Illinois Power Company

Docket No. 50-461

Subject: Clinton Power Station Unit 1
Humphrey Concerns

The referenced letter addressed some of the John Humphrey concerns as applicable to the Clinton Power Station (CPS). Enclosed are CPS responses on some additional Humphrey issues for NRC Staff review. Included are Action Plans #7, 9, 10, 11, 12, 13, 16, 17, 20, 23, 24, 27, 30, 34, 35, 36 and 37. We believe that these responses will resolve the particular concern involved.

Figure 1. Schematic of Vessel, Drywell, and Wetwell Systems Modeled by M3CPT04

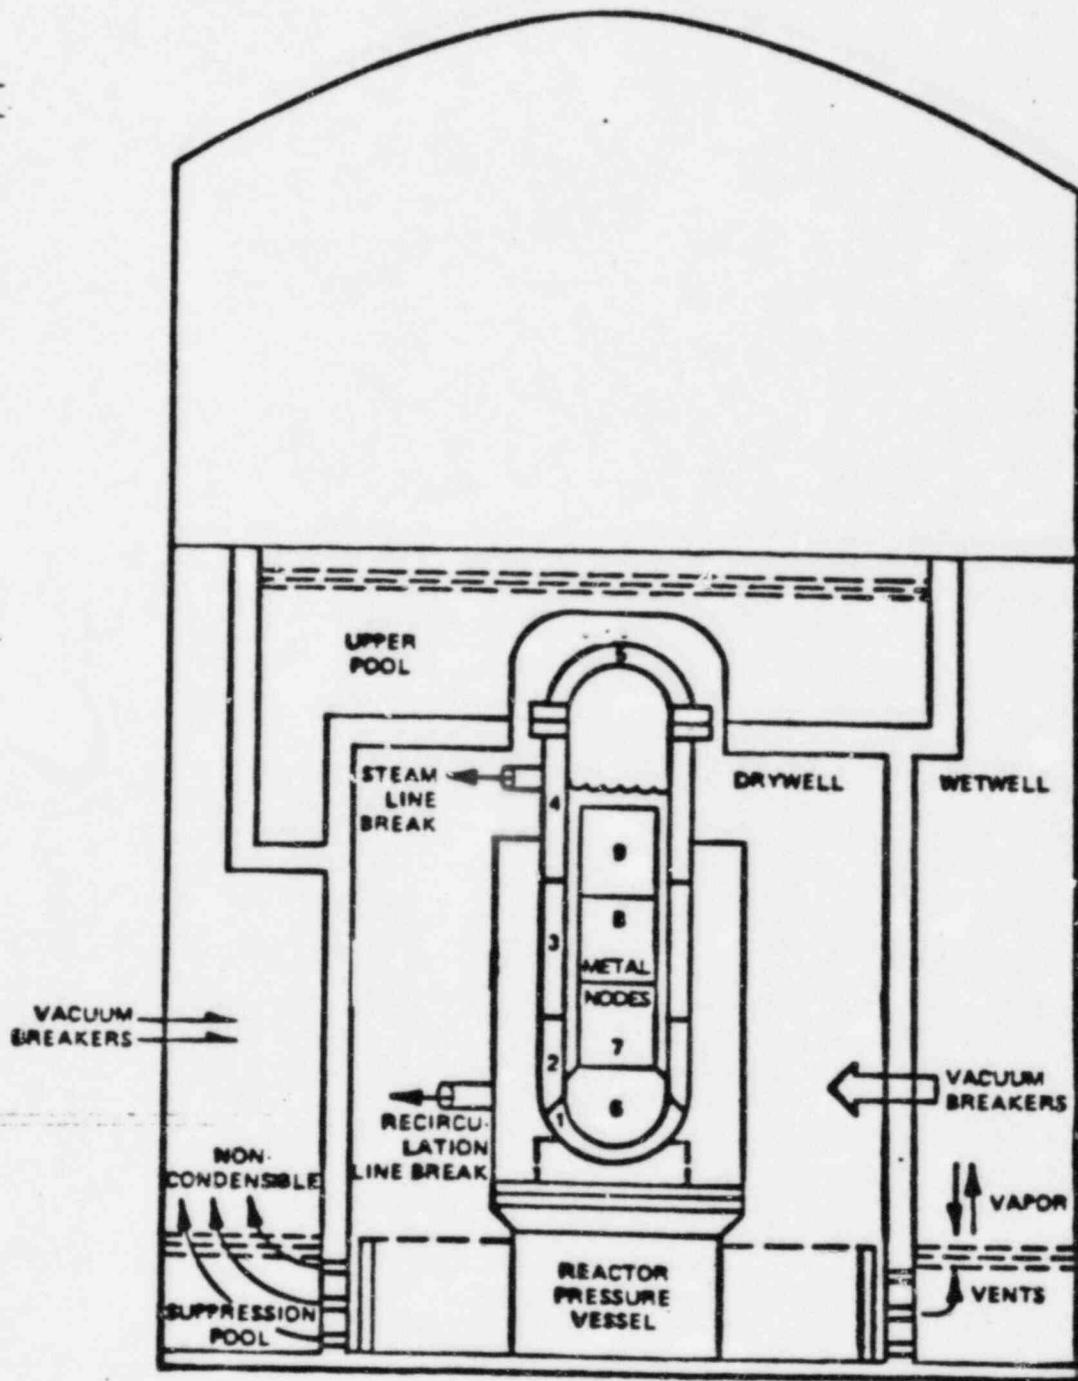
The purpose of the M3CPT (short-term) code is to calculate the dynamic pressure and temperatures responses associated with the inertia of clearing the vents of water. As documented in Reference 1, the short-term analytical M3CPT model is conservative when compared to pressure suppression test data. Details of the M3CPT code modeling are shown in Figure 1.

FIGURE 1

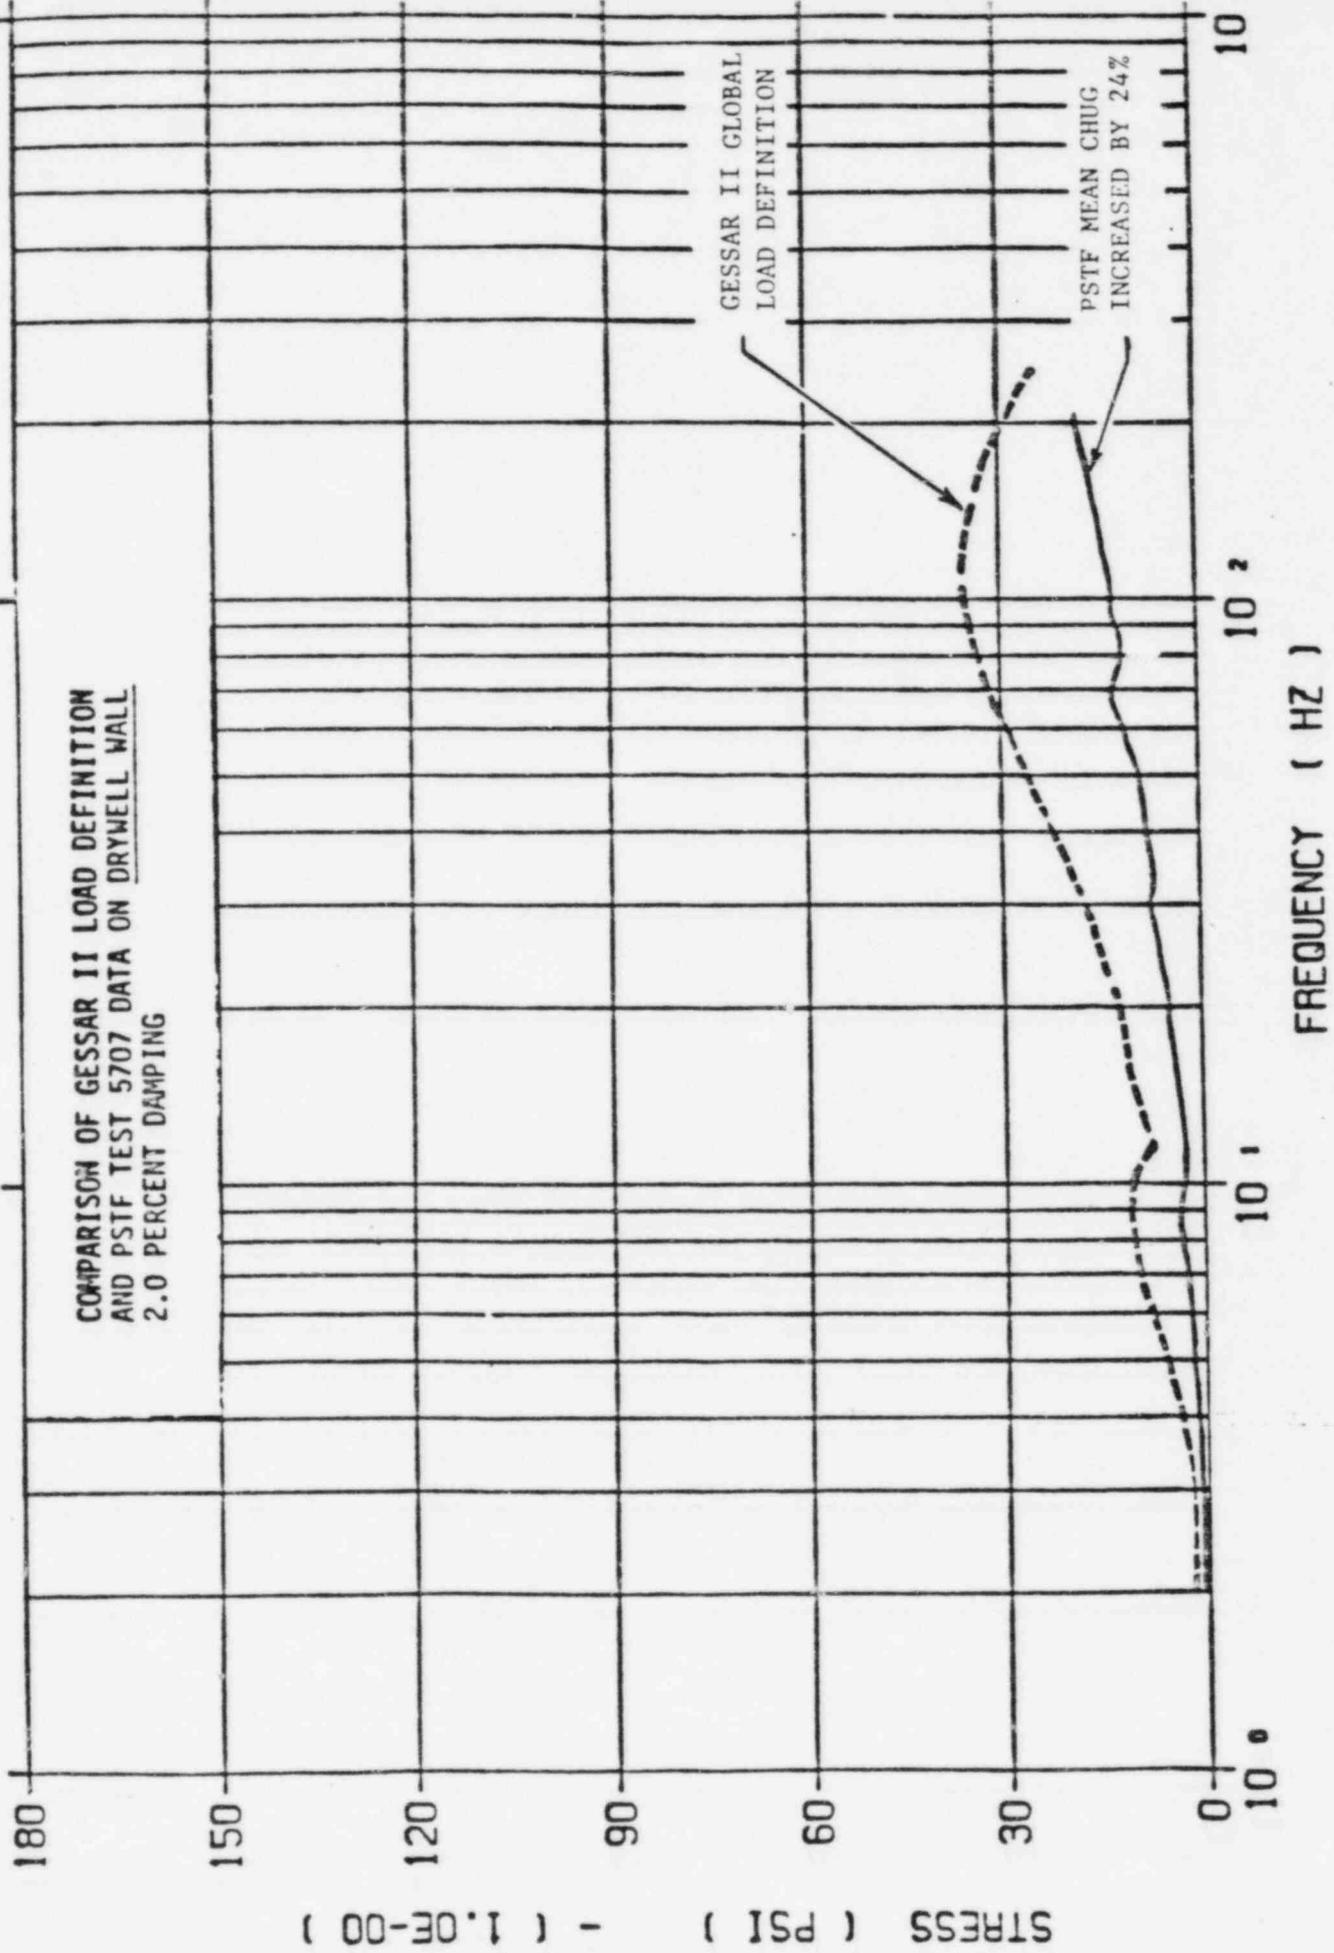
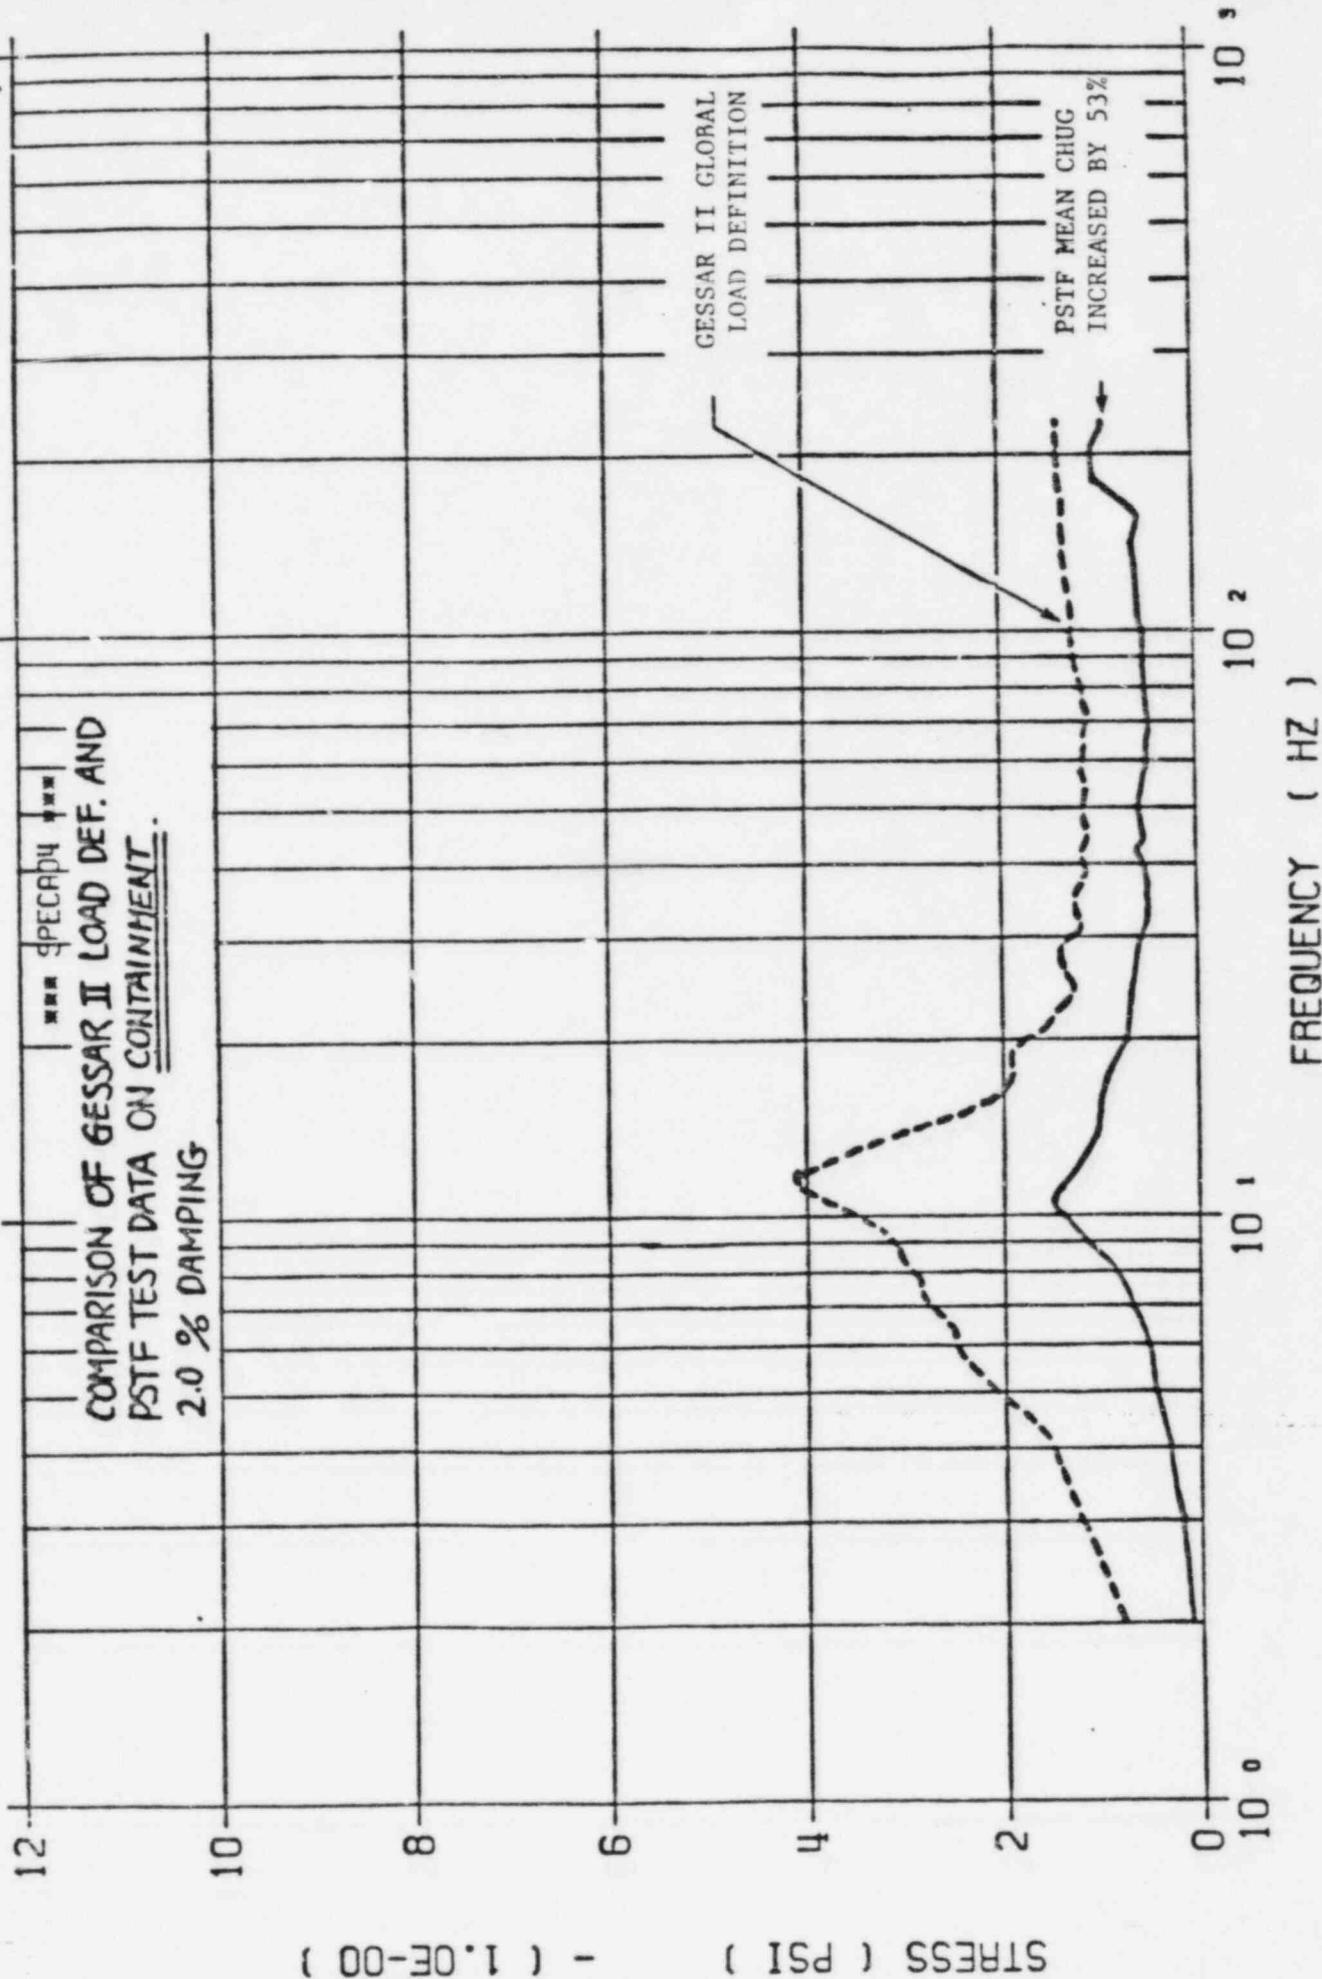
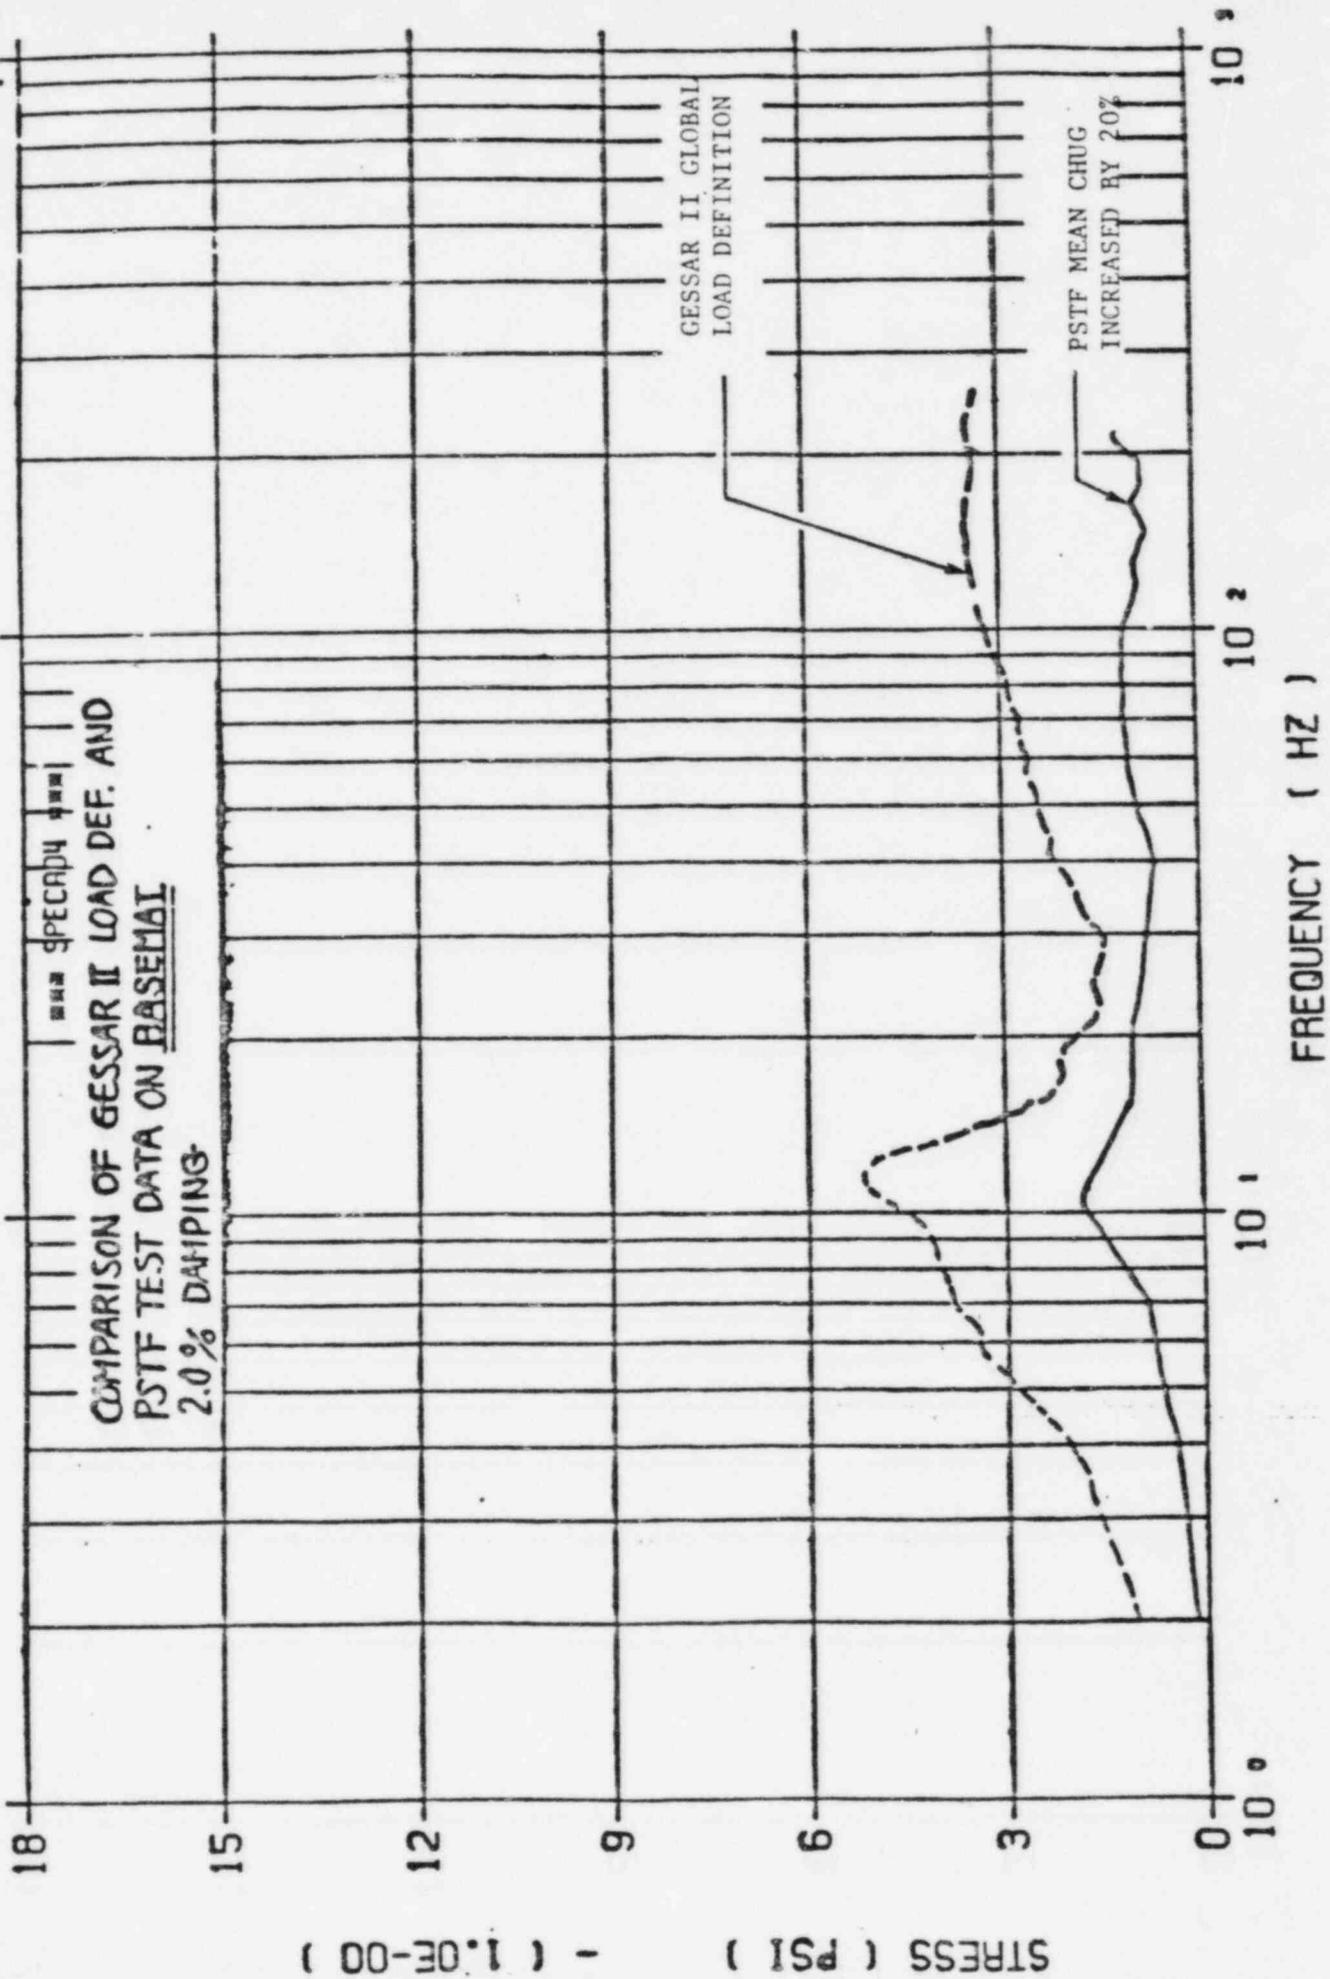
19.1 Submergence Effects on Chugging Loads

The chugging loads were originally defined on the basis of 7.5 feet of submergence over the drywell to suppression pool vents. Following an upper pool dump, the submergence will actually be 12 feet which may effect chugging loads.

Global load results were then obtained and compared with the GESSAR II global load definition for the three suppression pool boundary areas. The results showed that the GESSAR load definitions have sufficient margin to bound any submergence effects. Figures 1, 2, & 3 show those results.

It is thus concluded that the existing local and global load definitions adequately bound increased submergence effects on chugging pressure loads.
